Date: September 14, 2026
To: Shahab Araghinejad, Ph.D., P.E., Contract Manager, Division of Water Rights, Instream Flow Section, State Water Board
From: Al Preston, Ph.D., P.E. (CA), Project Manager, Geosyntec Consultants
Subject: **Model Documentation Report for the Groundwater-Surface Water Model for the Ventura River Watershed - Correction of Figures 5.21, 5.22, and 5.23.**

Figure 5.21 Annual Volume Plots for Gages 604, 603A, and 602B

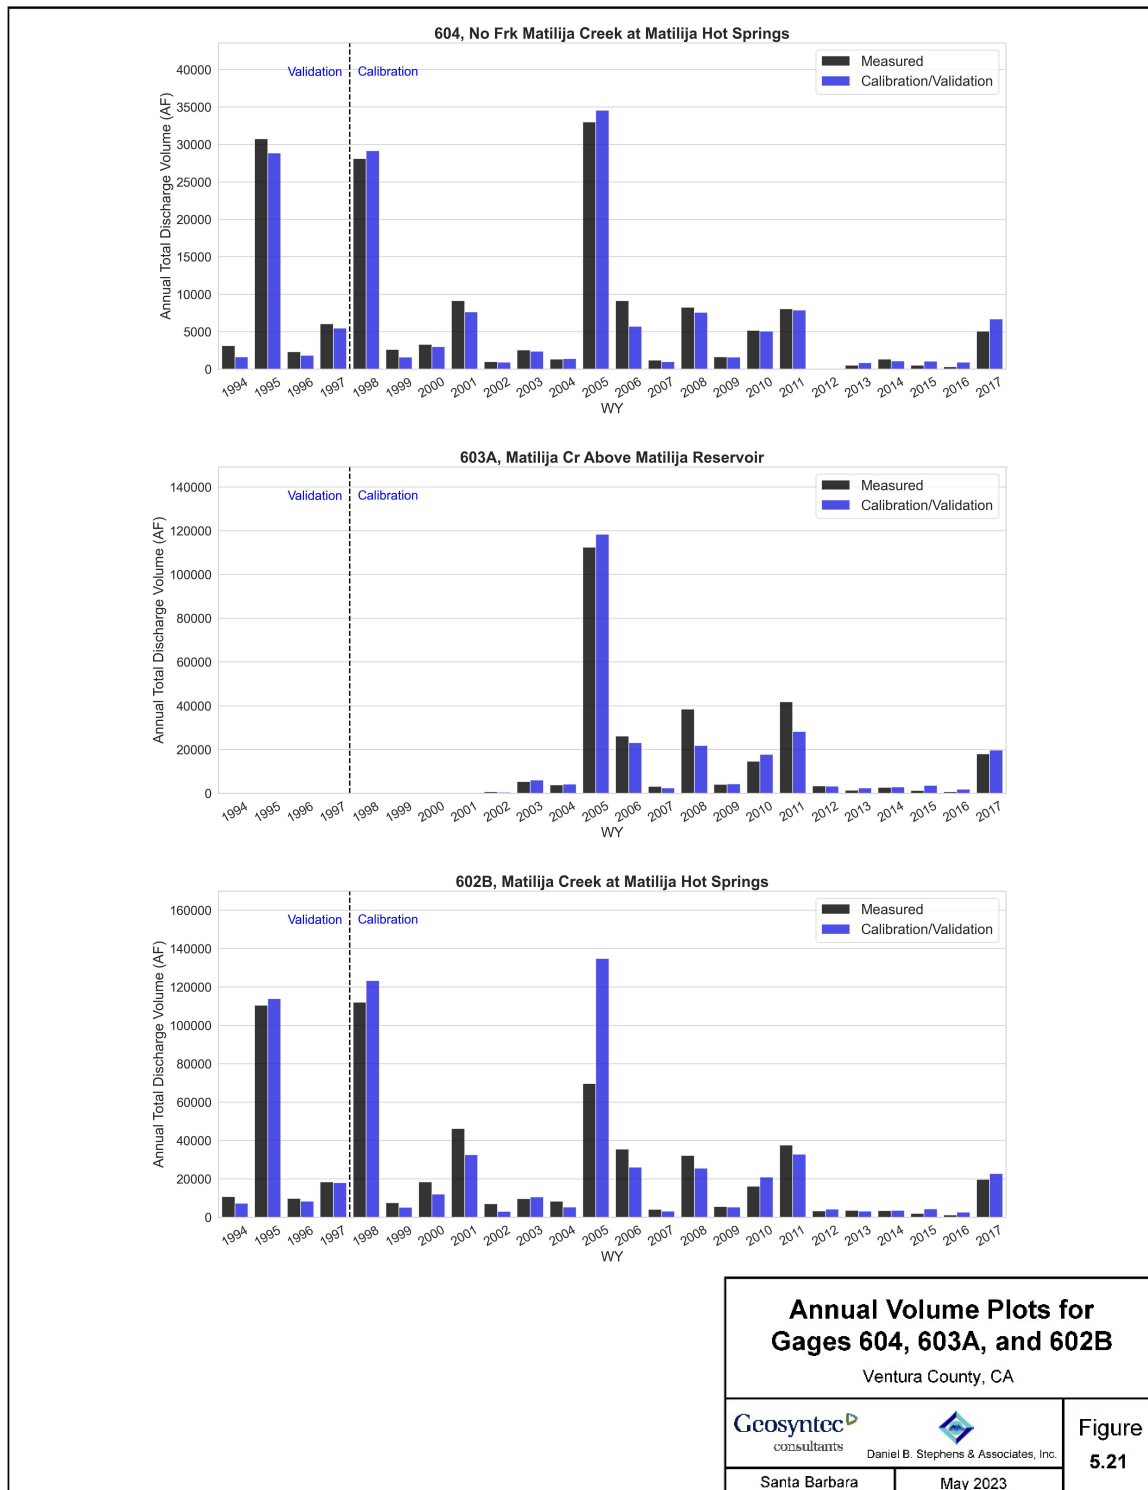
The original figures had an error on the vertical axis scales that have been corrected in the attached versions. Since the scale errors were applied to both the model results and the measured results, the trends in the bar charts remain the same, and there is no impact on the model calibration/validation results or conclusions drawn from the modeling.

Please see attached corrected Figures 5.21, 5.22, and 5.23 for the Model Documentation Report for the Groundwater-Surface Water Model for the Ventura River Watershed, published in March 2026. These figures were on pages 207, 208, and 209, respectively.
